### Town of Kittery Planning Board Meeting September 12, 2019

#### ITEM 2 – 76 Dennett Road – Site Preliminary Plan Review

Action: Approve with or without conditions, continue consideration of or deny plan. Owners William J. Cullen and Sail Away, LLC and applicant William Wharff request consideration of a mixed-use residential development on 23.3+- acres of land at 76 Dennett Road (Tax Map 6 Lots 15B & 16A and Tax Map 13, Lot 4) in the Mixed Use - Neighborhood (MU-N) Zone. Agent is Shawn Tobey, P.E. Hoyle, Tanner & Associates, Inc.

Conceptual Floor Plans - Building 1, Clubhouse, and Garage

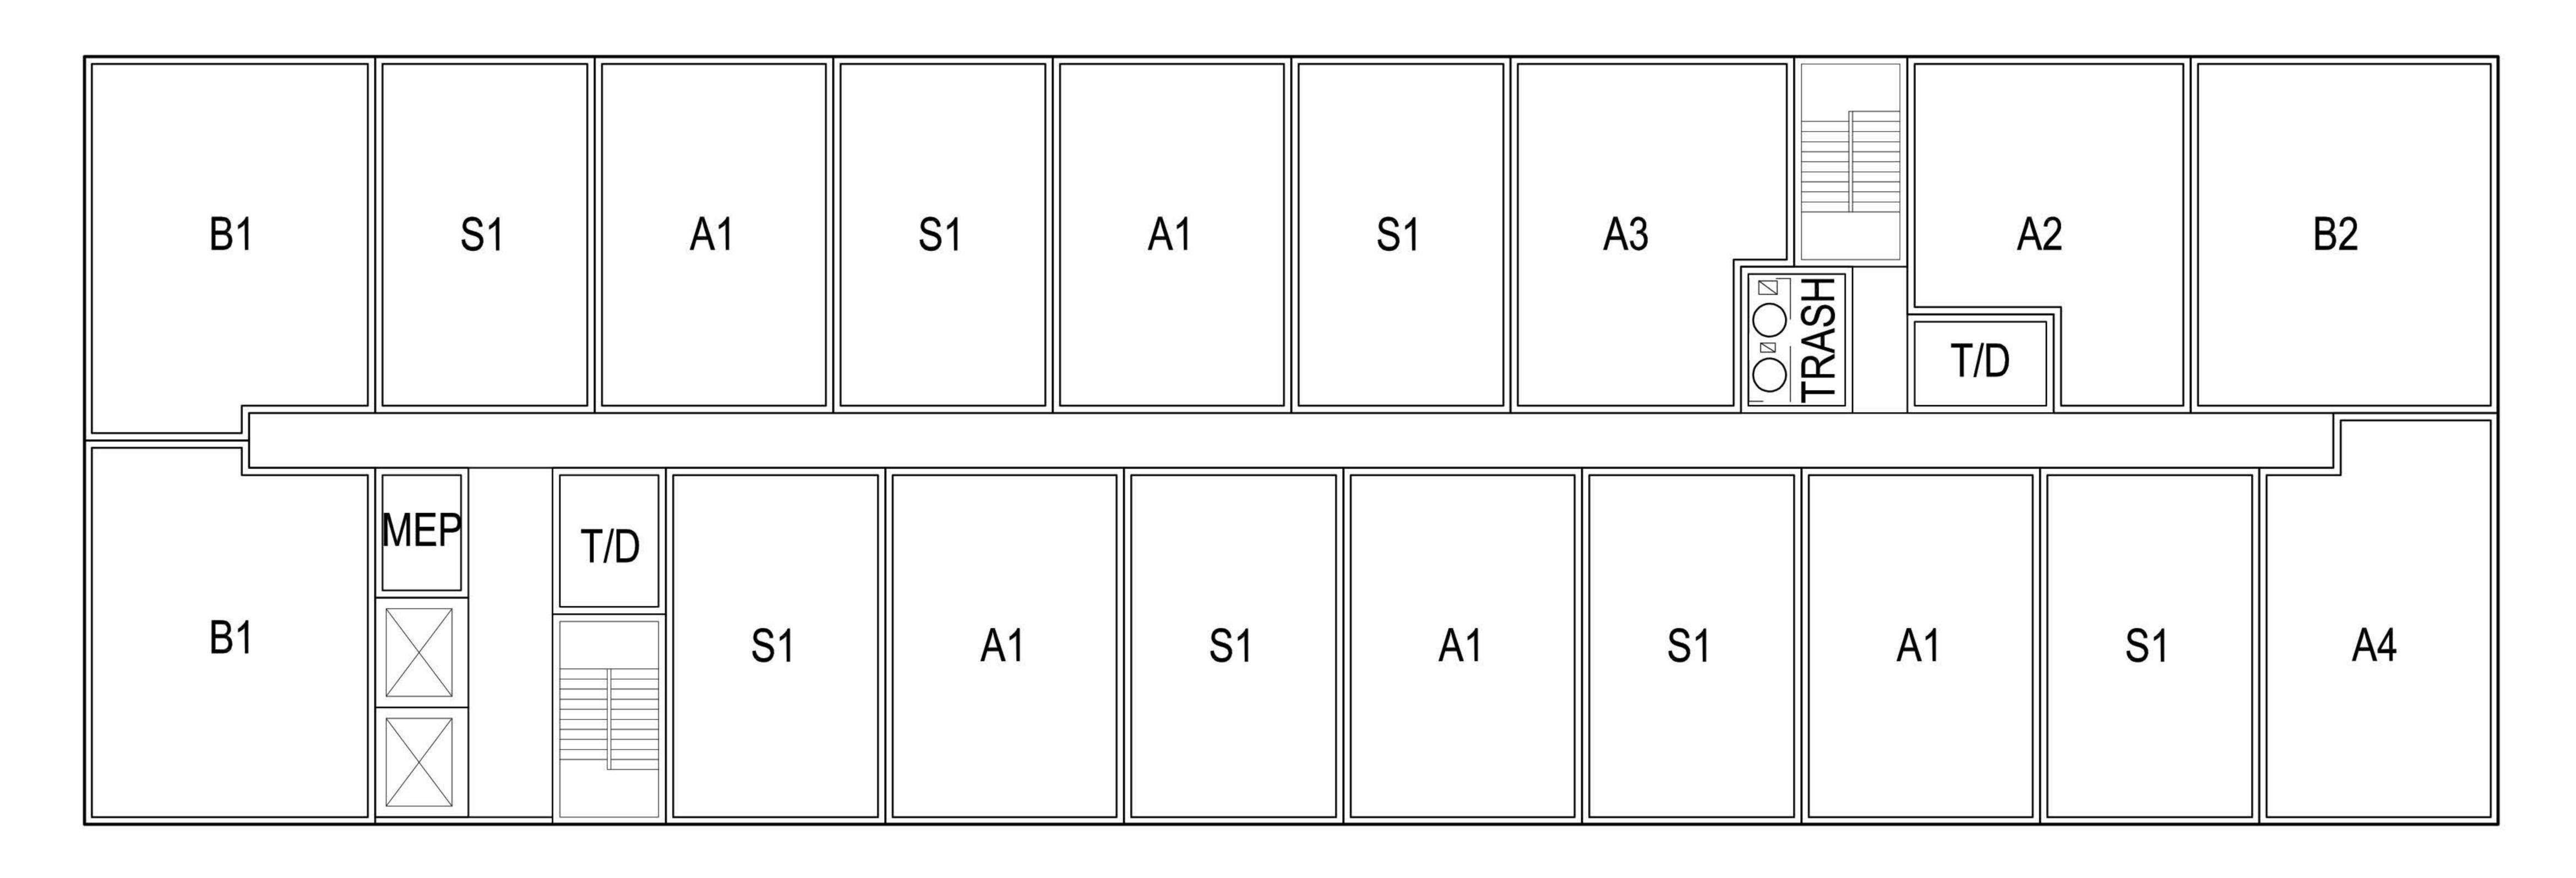
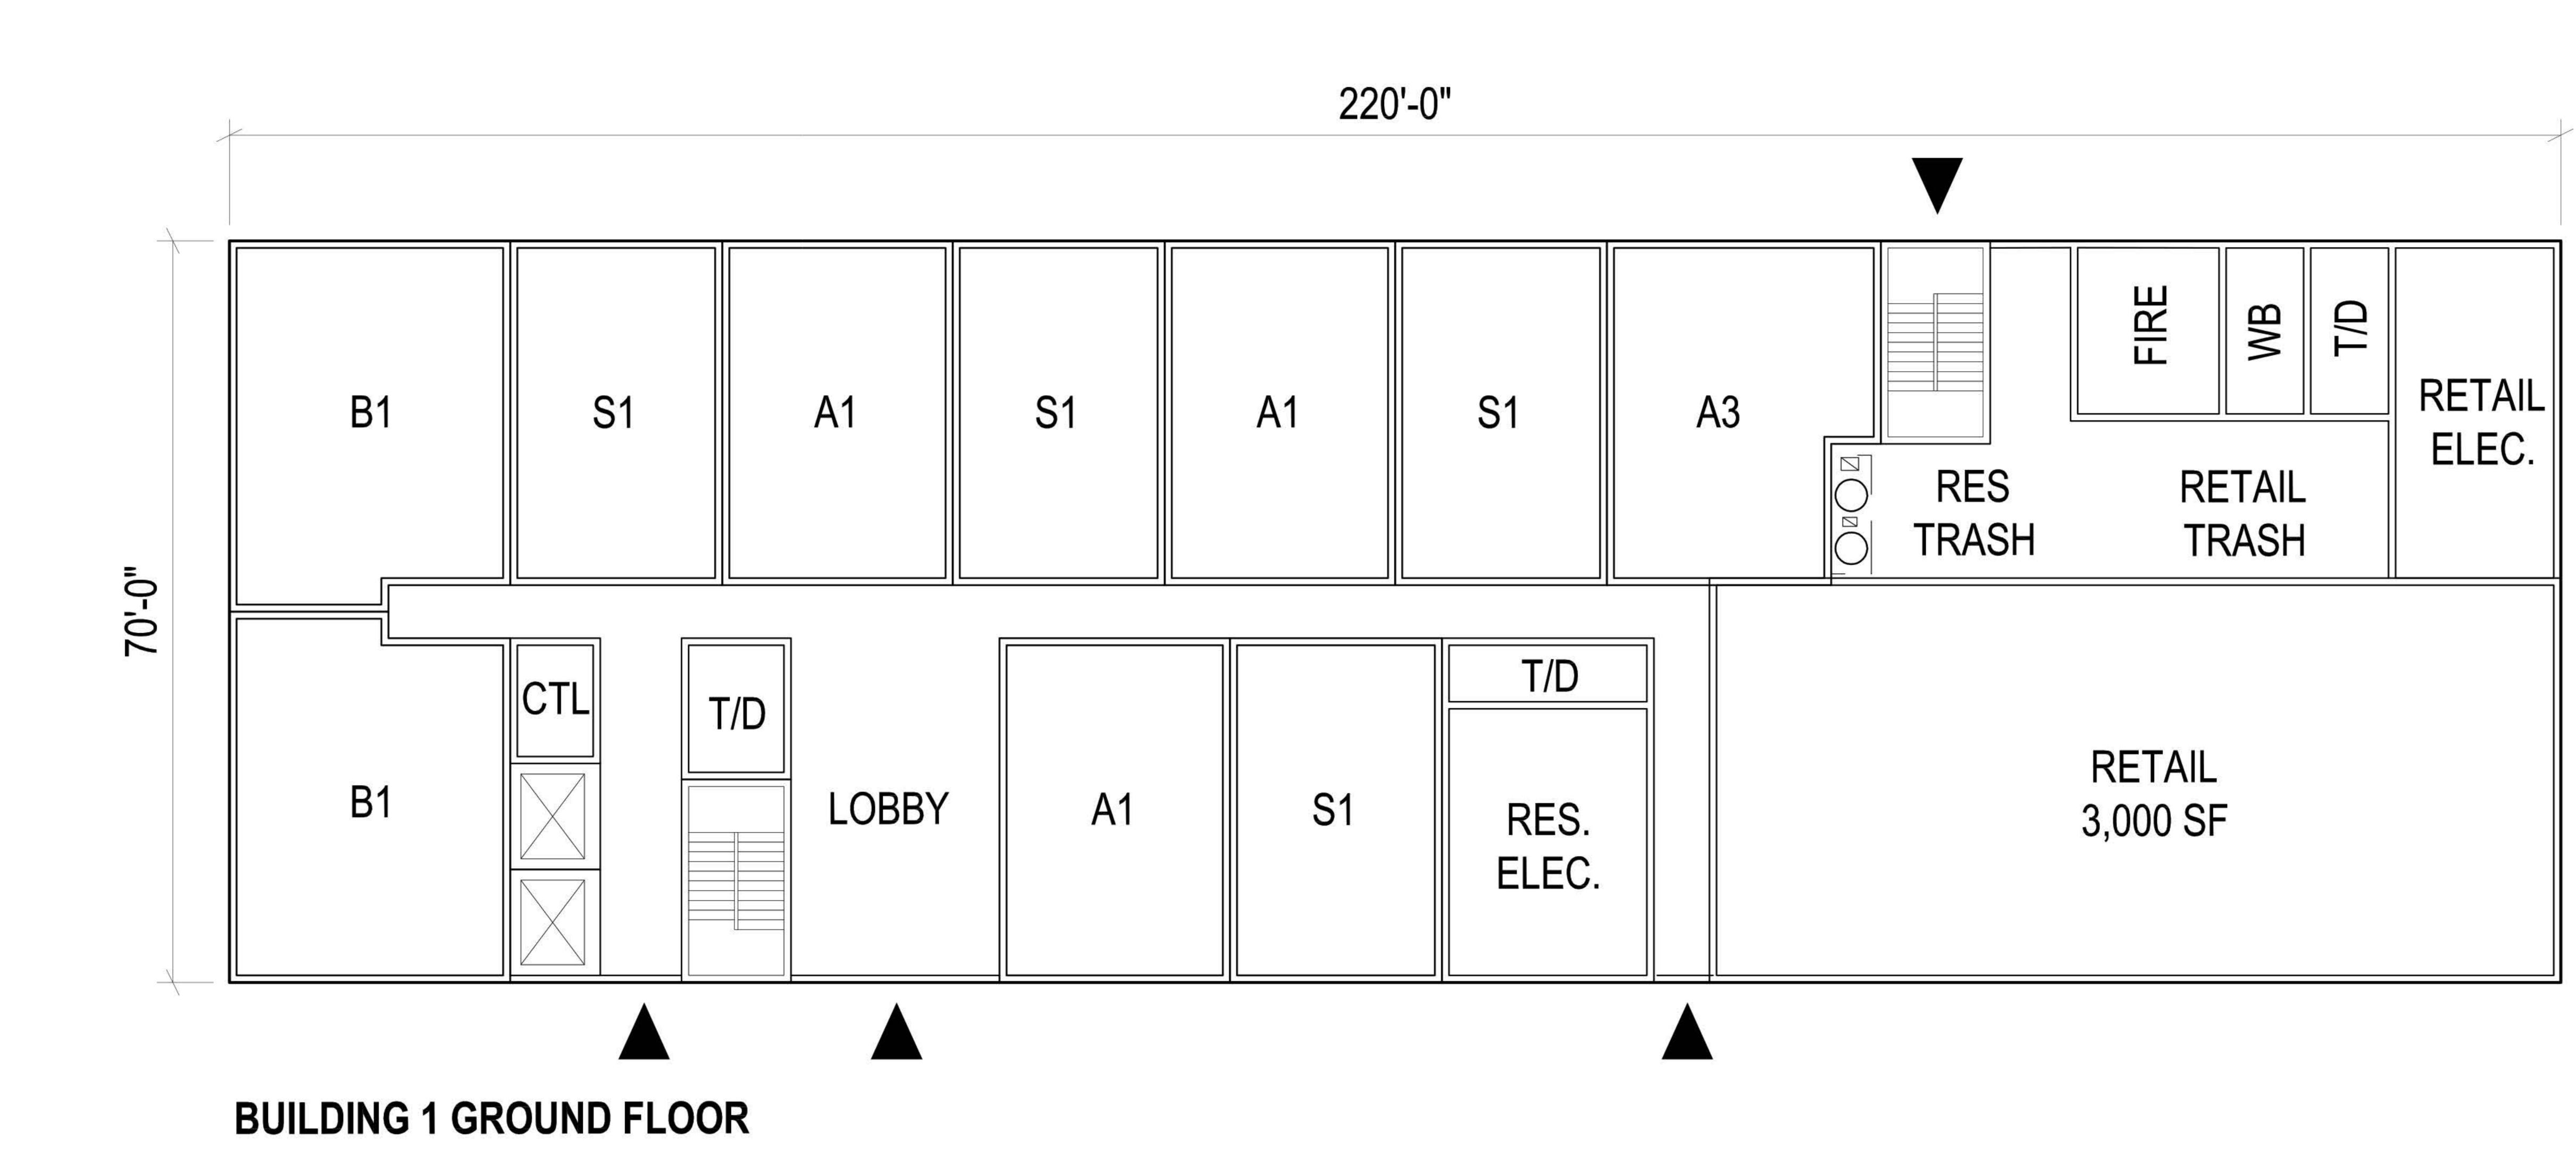
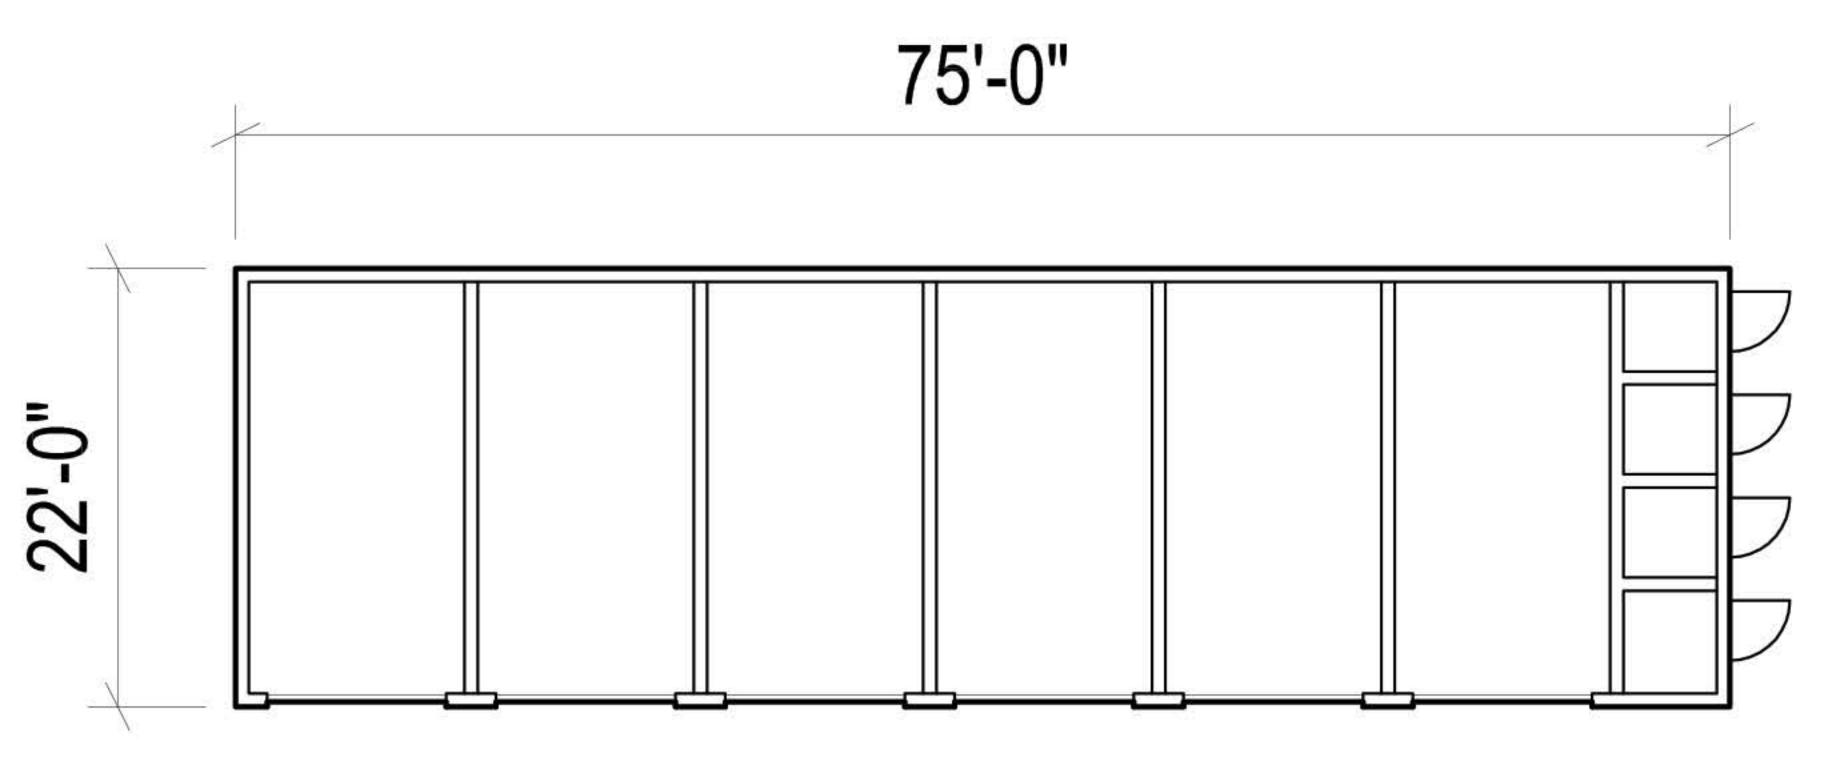
- 2. The Conceptual Floor Plans shall be revised to indicate that the studio apartments will contain a minimum of 650 sf of habitable space;
- 3. Completion of a third-party review of the proposed landscaping plans;
- 4. Provide details of the proposed sidewalk for the full length of the property for Final Plan review; and,
- 5. Address to the satisfaction of CMA Engineers their 2<sup>nd</sup> round of plan review comments.

- All studio units were revised to be a minimum of 650 SF.
- A legend was added.
- Dimensions depicting building heights were added to the elevations
- Building material callouts were added to the elevations.
